Turtle Creek 89204

Re: Plan Review
Glen Eagle Subdivision: Detention Calculations (11/15/91)
Plans Revised (7/16/92)

PLAN REVIEW
CITY OF O'FALLON, MISSOURI

GLEN EAGLE SUBDIVISION
DETENTION CALCULATIONS

CHART 1

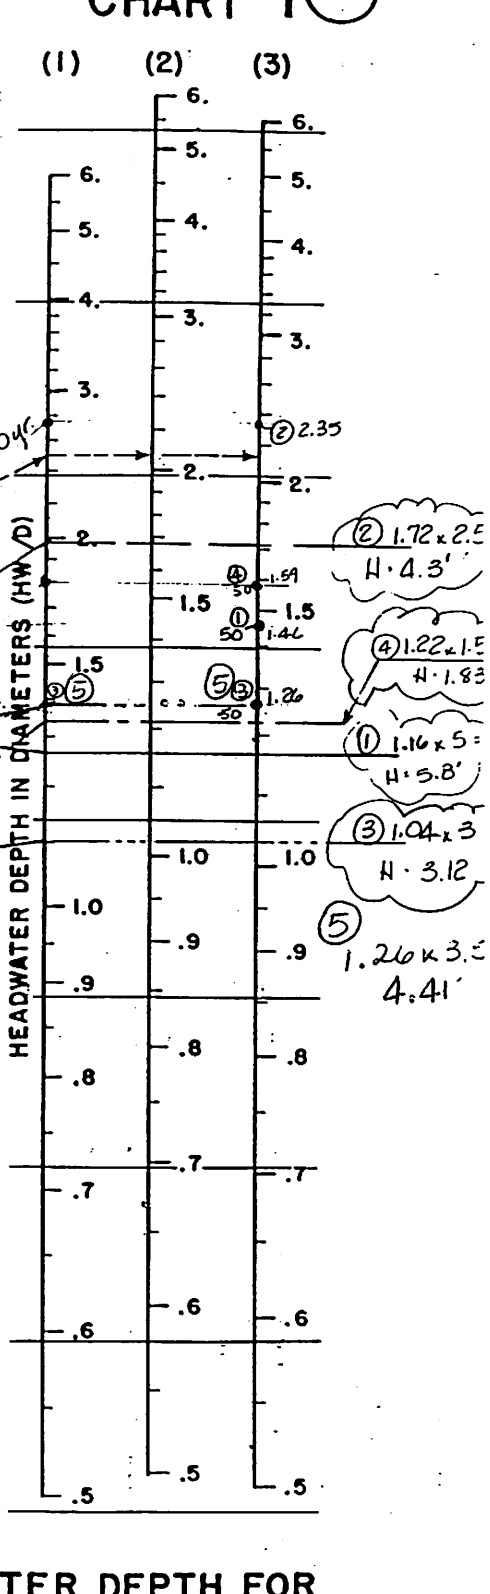
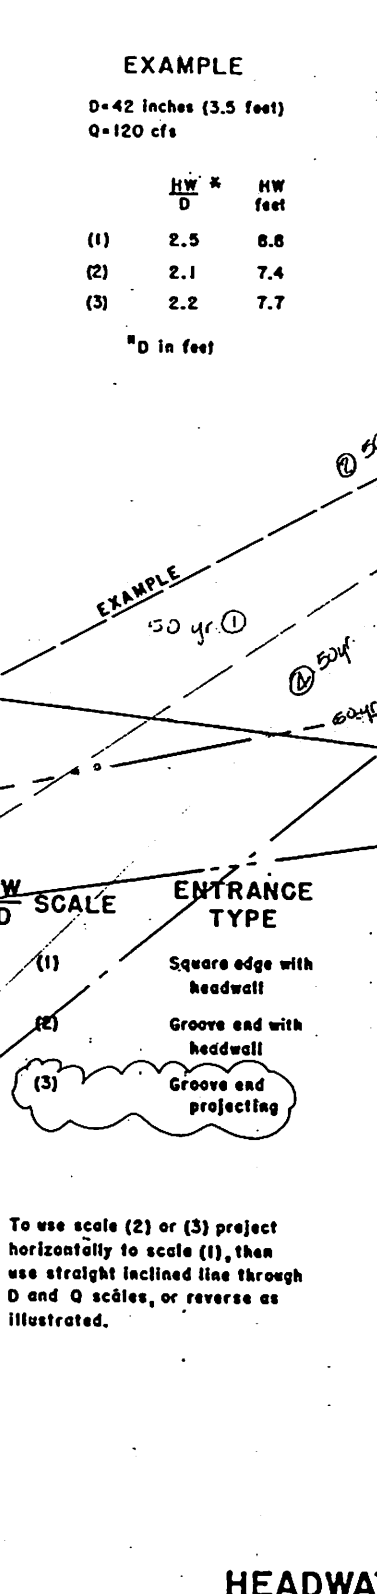
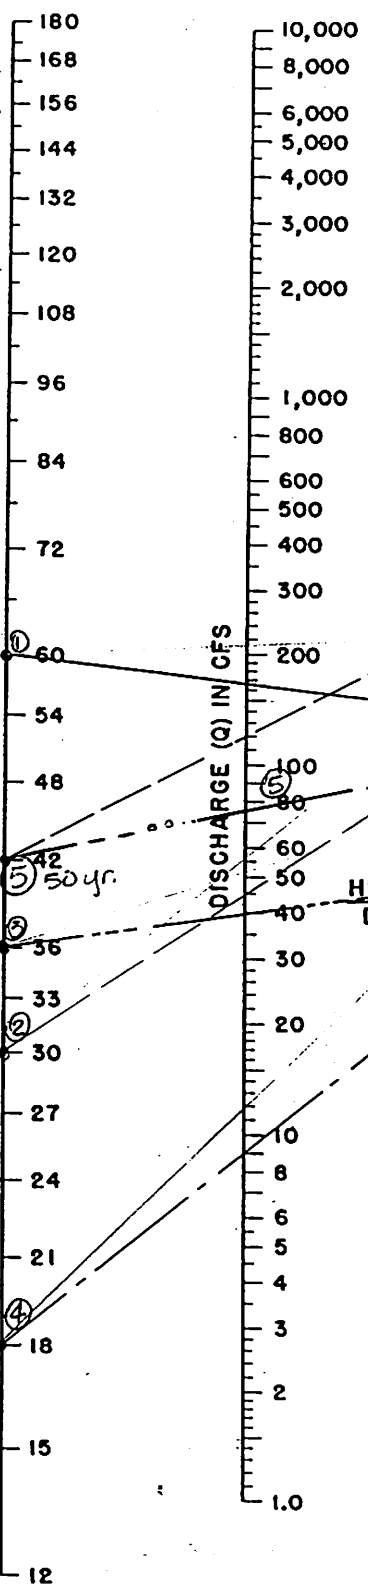
Item No.	Topic / Description	Action By
4	FE S-67	
	HW 1.83	
	HW ₅₀ 2.39	
	<u>£ 592.00</u>	
	£ 592.00	
	593.83	
	594.39	
	Top Berm = 598.0 vs 594.39 ok	
<i>Tdk</i>	<i>Rev. 8-2-94 Tdk</i>	
	<i>FE S-75</i>	
	<i>HW₅₀ 4.41</i>	
	<i>£ 588.00</i>	
	<i>592.41</i>	
	<i>Top Berm = 594.5 vs 592.41</i>	<i>2' OK</i>

② 1.72 x 2.5 = 4.3'

④ 1.22 x 1.5 = 1.83'

① 1.16 x 5 = 5.8'

③ 1.04 x 3 = 3.12'

⑤ 1.26 x 3.5 = 4.41'

CHART 1

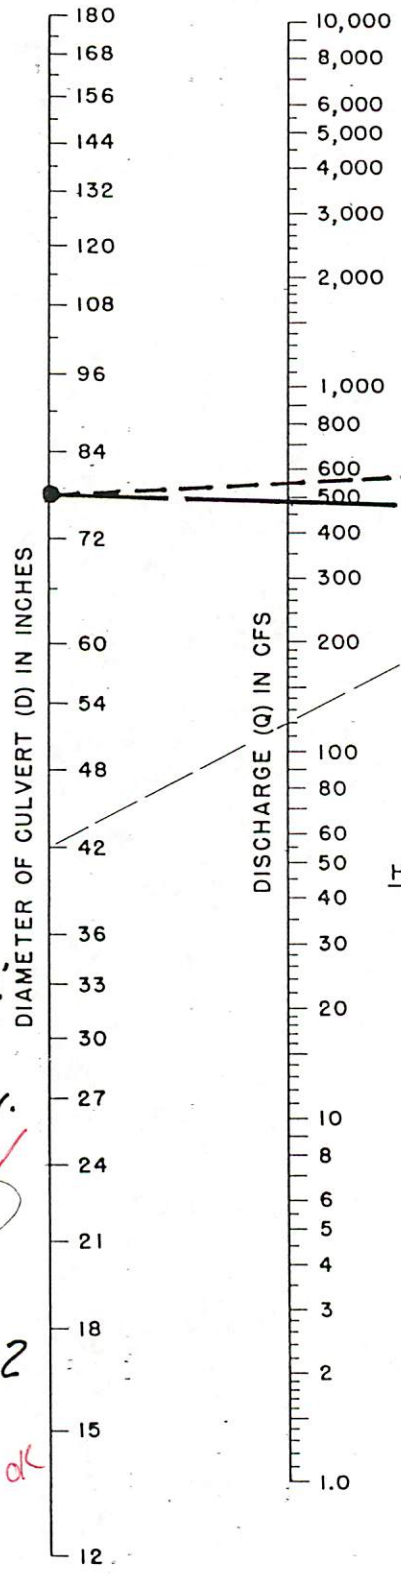
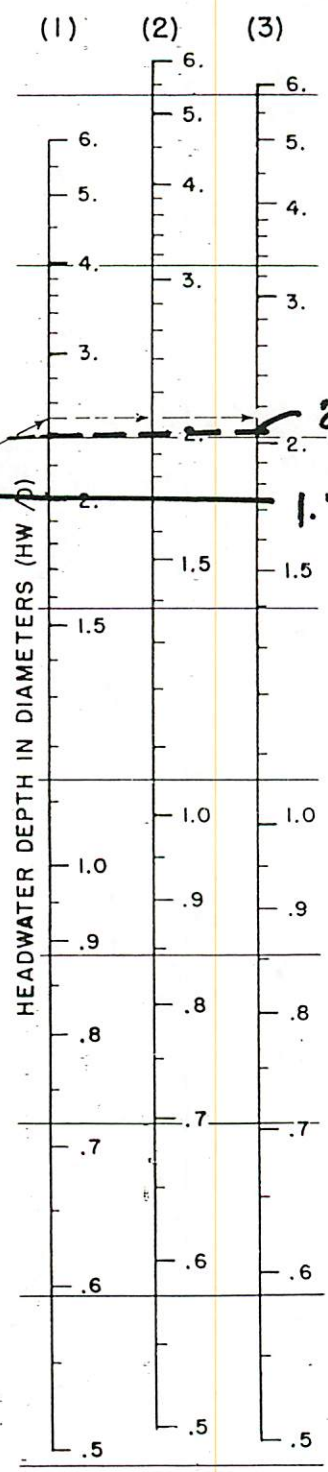
50 yr. :
6.5 x 1.73 = 11.24'
563.22 + 11.24 =
574.46 ELEV.

VS
577.4 ✓
FB = 2.9'

100 yr. :
6.5 x 2.05 = 13.32'
563.22 + 13.32 =
576.54

9' FB ok

Section Thru
Primary Spillway Lake 17

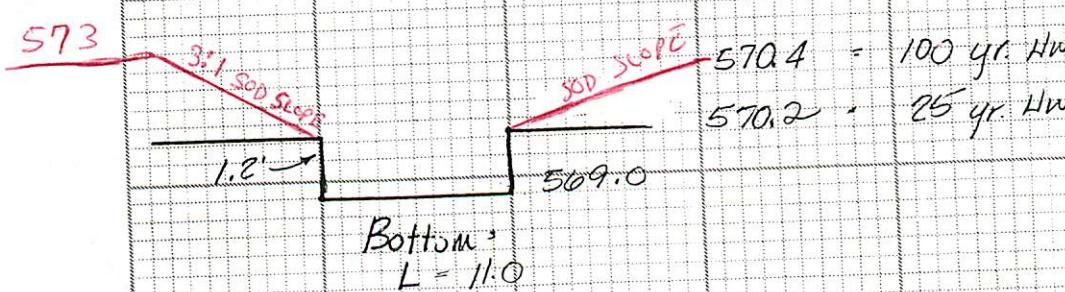
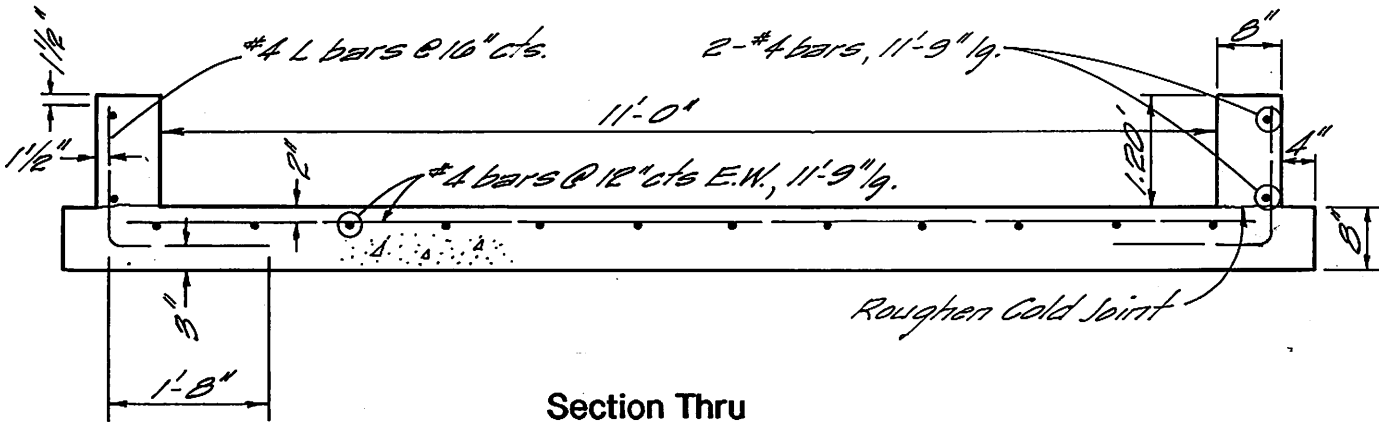
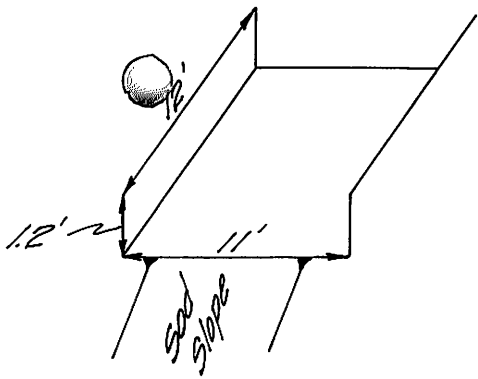
Revise "Principle Spillway" :

$Q_{25} = 38.19 \text{ cfs}$

$Q = CLH^{3/2}$
 $= 2.68(11.0)(1.2)^{3/2}$

$Q = 38.75 \text{ cfs}$

$V = \frac{Q}{A} = \frac{38.75}{13.2} = 2.93 \text{ F.P.S.}$
OK
